Connah's Quay Low Carbon Power

Applicant's Response to Local Impact Report

Planning Inspectorate Reference: EN010166

Document Reference: EN010166/APP/9.15

Table 7: Statistical Summary of Daytime and Night-time Background Sound Levels (L_{A90}) (LT 8)

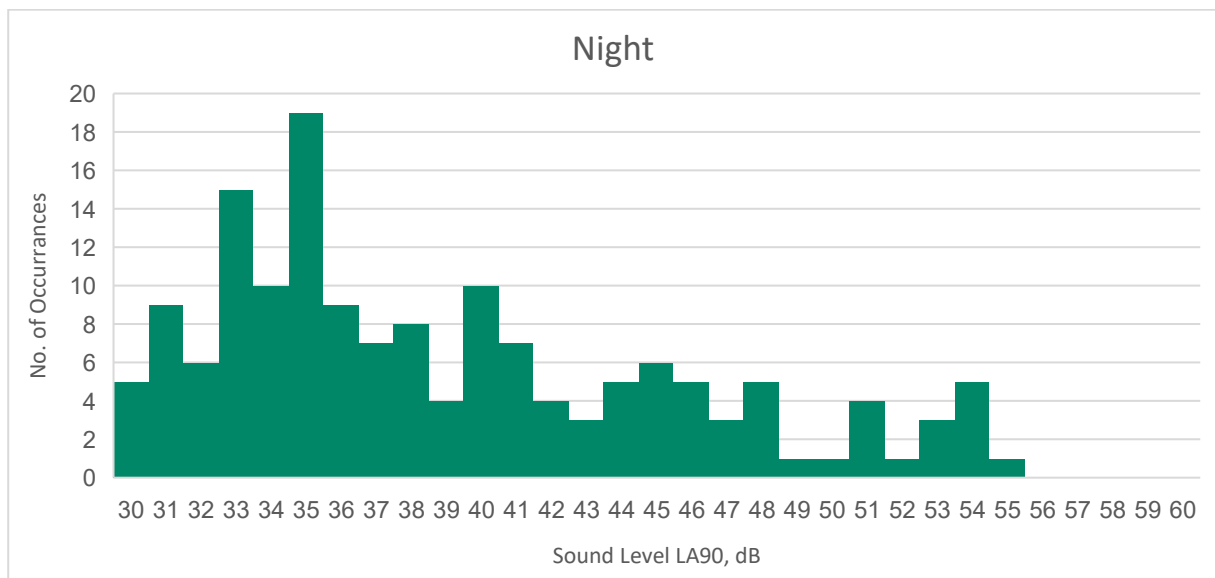
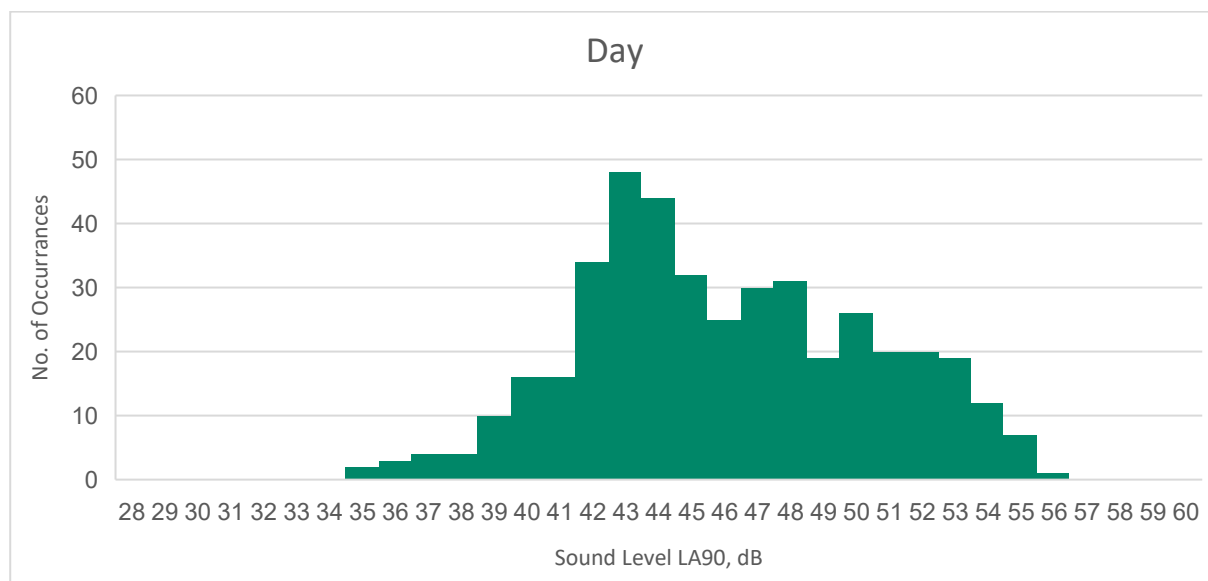
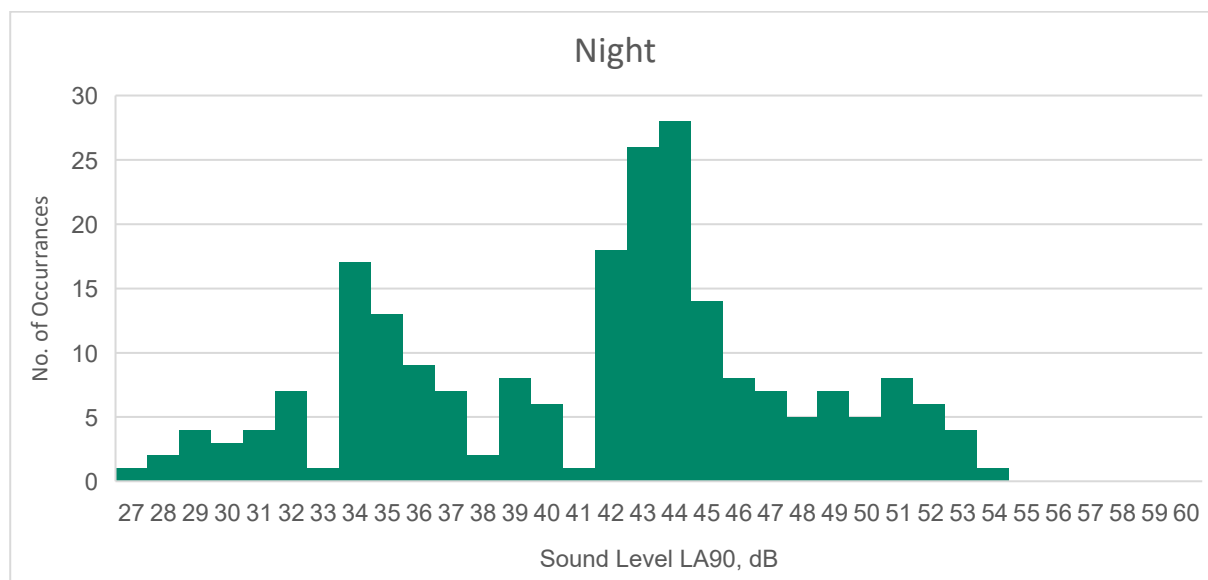
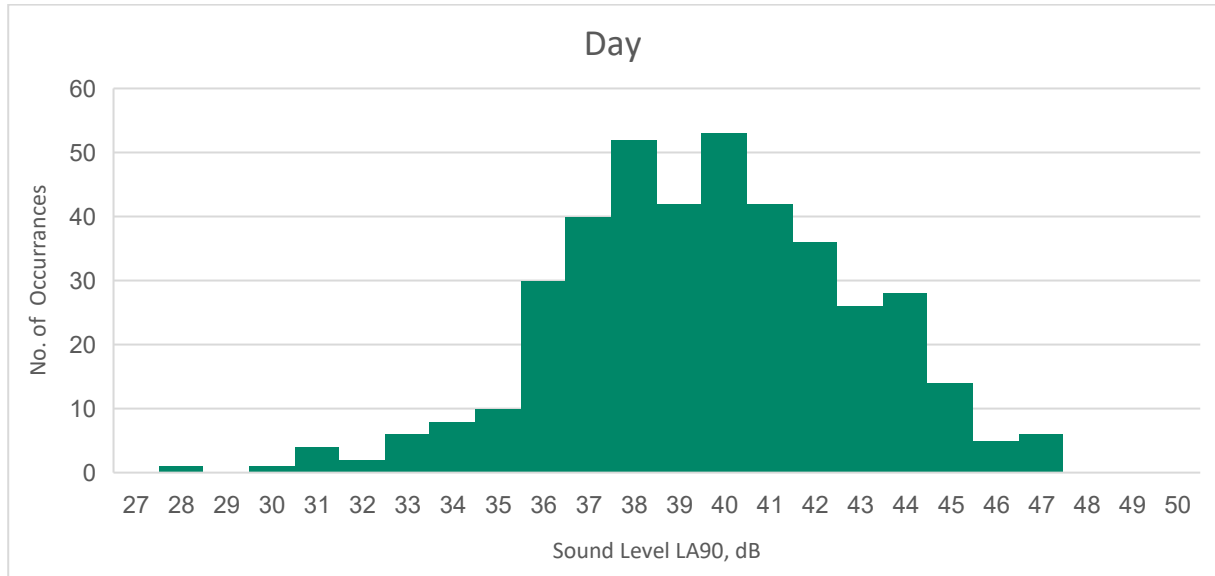
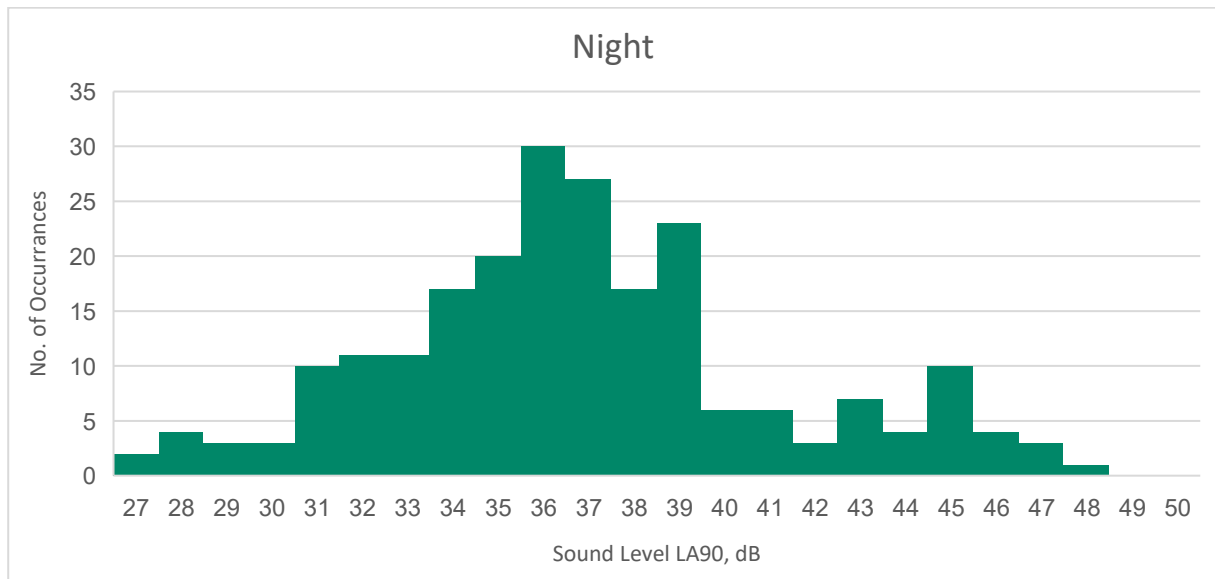
Reference	Source Document Text	Applicant's Response
10.8	A baseline sound survey has been undertaken combining long-term and shortterm measurements. The measurement locations (shown in Figure 9-1 [APP- 120]) are appropriately distributed in relation to noise sensitive receptors and the proposed development site to provide a sufficient representation of the sound environment.	the histogram plots that show the distribution of the L_{A90} data in Appendix A of this document.
